This page lists the know errors on the gm5x5x5 PCBs. There are no known issues with the bulk order run (white pcbs), the following information is valid **only** for the prototype run (green pcbs).

http://wiki.midibox.org/doku.php?id=gm5x5x5_errata&rev=1249323111

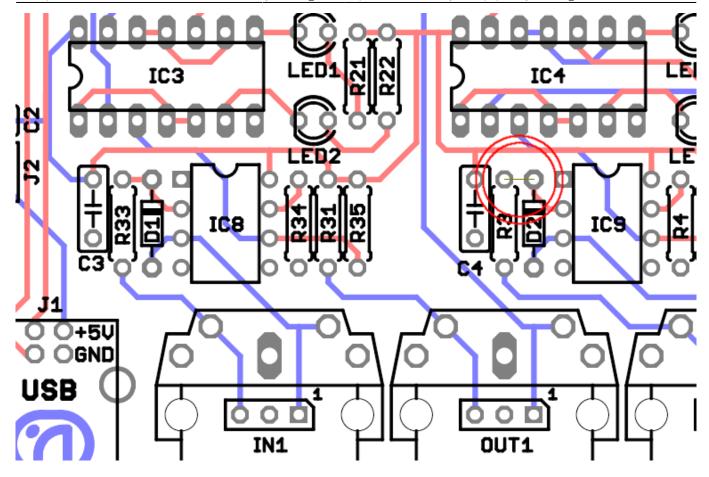
Problem: The MIDI IO pins of the midi sockets (Pin 4 + 5) are switched.

Solution: Either (1) use the pin-headers if you use sockets that are not mounted on the pcb or (2) break the traces to pins 4 + 5 of the sockets and solder wires to them or (3) solder the midi sockets on the other side of the pcb.
